Subject: **Docket Nos. 50-361 and 50-362
Additional Information Regarding Generic Letter 96-06 "Assurance
of Equipment Operability and Containment Integrity During
Design-Basis Accident Conditions,"
San Onofre Nuclear Generating Station, Units 2 and 3
(TAC Nos. M96862 and M96863)**

**Response to the Request for Additional Information
Regarding the September 29, 2003
Supplemental Response to Generic Letter 96-06
"Assurance of Equipment Operability and Containment Integrity
During Design-Basis Accident Conditions"**

MSLB @ 102% POWER W/MSIV FAILURE CONTAINMENT PRESSURE

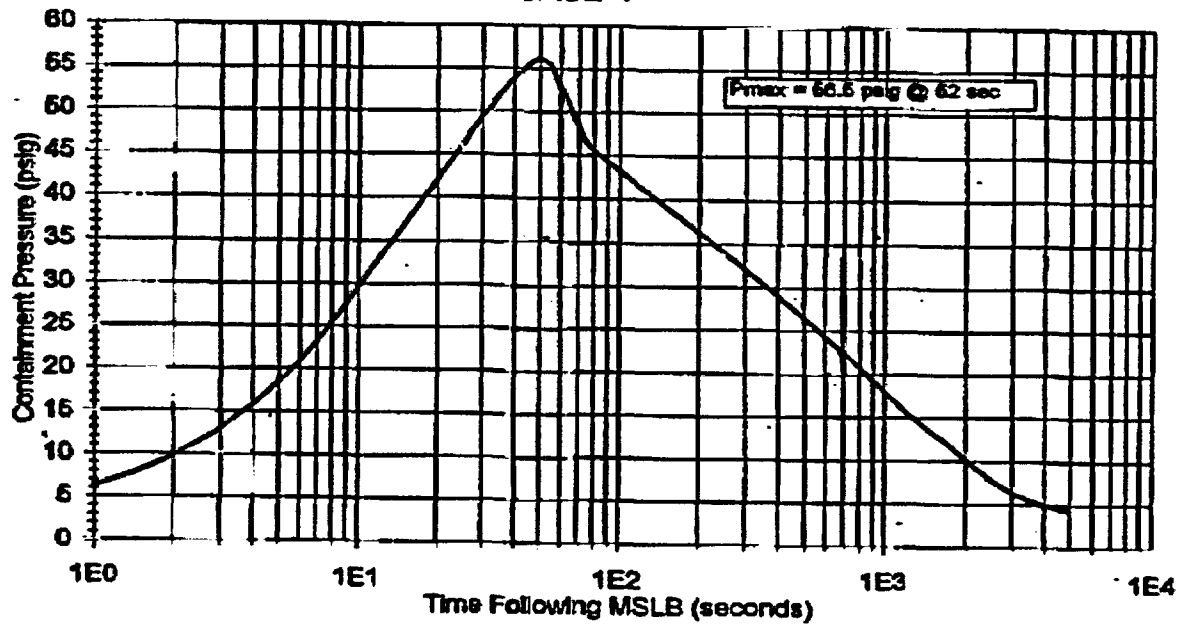
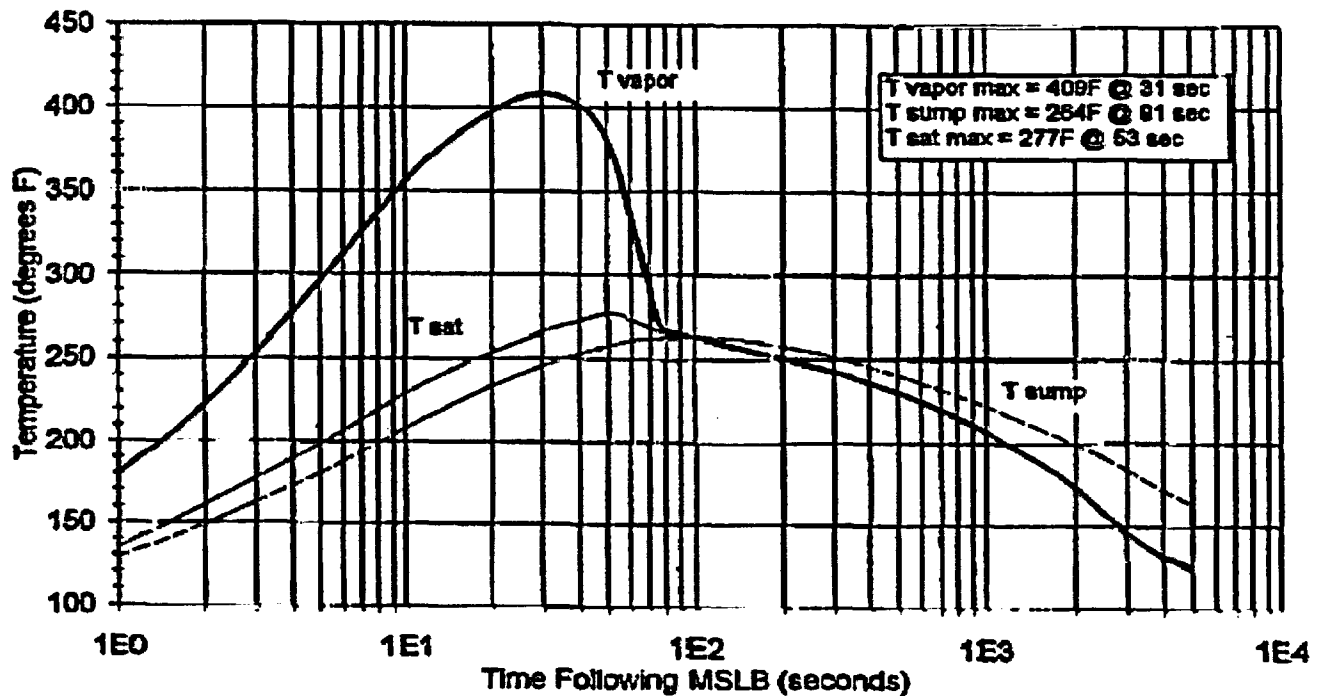
Provide graphs showing the containment atmospheric temperature and pressure as a function of time for both the LOCA and MSLB case.

The condensation heat transfer coefficients (for saturated steam) are significantly greater than the sensible heat convective heat transfer coefficients for superheated vapor. As shown in the attached figures (see page 12), the saturation temperatures for the MSLB are much lower than the containment temperatures. Thus, the steam in MSLB is significantly superheated. Hence, for steam to begin condensing over the ECU tubes it has to first pass over successive cooler tubes to cool down to the saturation temperature and lose the superheat by convection.

The MSLB and LOCA pressure and temperature curves are provided on pages 12 and 13, respectively, of this response.
